SUBJECT: FLOW DEPENDENT MINIMUM CRITICAL POWER RATIO (MCPR), SUSQUEHANNA  
STEAM ELECTRIC STATION, UNIT 1 (TAC NO. M83360)

AMENDMENT TO FACILITY OPERATING LICENSE

Amendment No. 122  
License No. NPF-14

SAFETY EVALUATION BY THE OFFICE OF NUCLEAR REACTOR REGULATION  
RELATED TO AMENDMENT NO.122TO FACILITY OPERATING LICENSE NO. NPF-14

**FLOW DEPENDENT MCPR OPERATING LIMIT**  
**FIGURE 3.2.3-1**

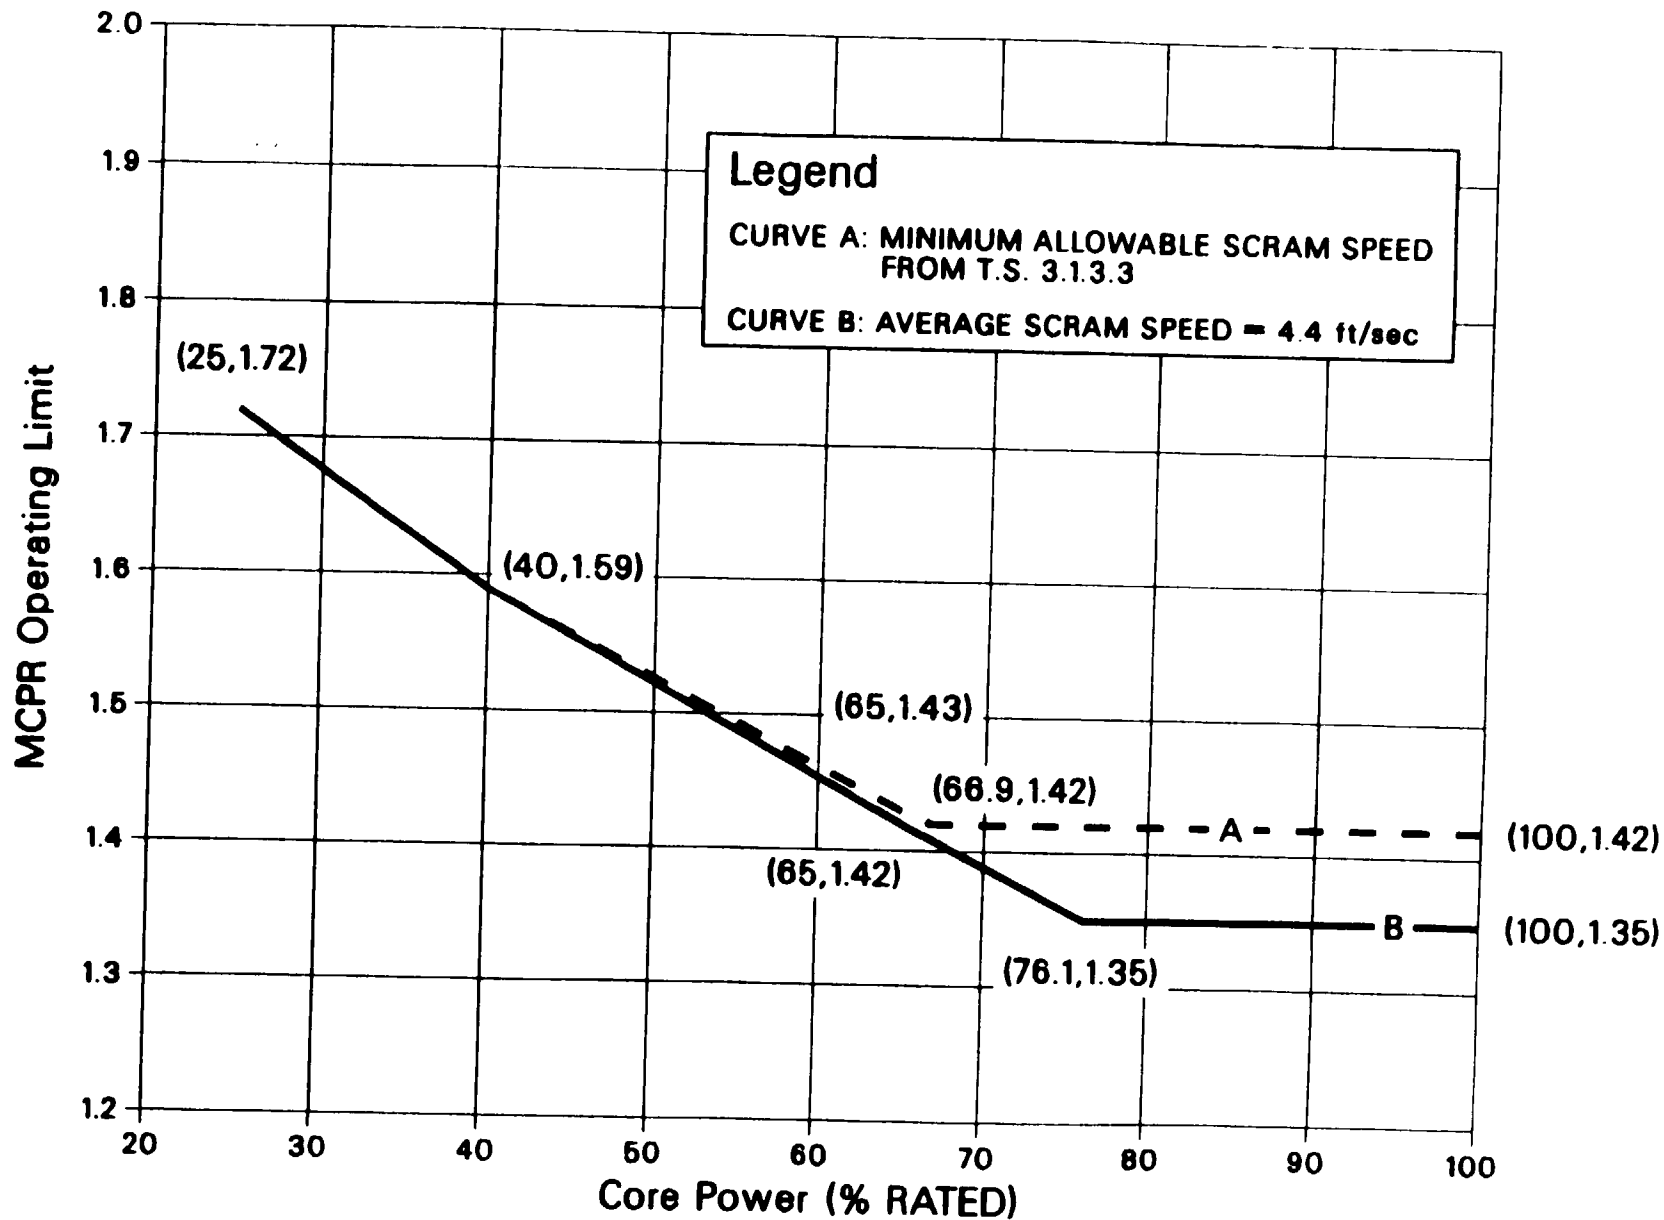
After issuance of Amendment 118, the licensee discovered an error in the calculation of the Unit 1 Technical Specifications flow-dependent MCPR operating limit curve. The corrected MCPR Operating Limits were entered into the licensee's Powerplex core monitoring system on May 15, 1992 under administrative control and staff agreement. The licensee is currently operating under these corrected limits and is making this change to the Technical Specifications to make the corrections to the calculational error permanent.

The single calculational error affected TS Figure 3.2.3-1. The corrected Figure 3.2.3-1 is consistent with the proper implementation of the licensee's NRC-approved licensing methods in support of Unit 1 Cycle 7 operations. The new curve presented in Figure 3.2.3-1 is more restrictive over the entire range where the recirculation flow controller failure event transient is limiting.

The staff finds this change to be acceptable. The corrected Figure 3.2.3-1 will ensure reactor operation within its design basis and preserves the validity of the Unit 1 Cycle 7 reload safety analysis.
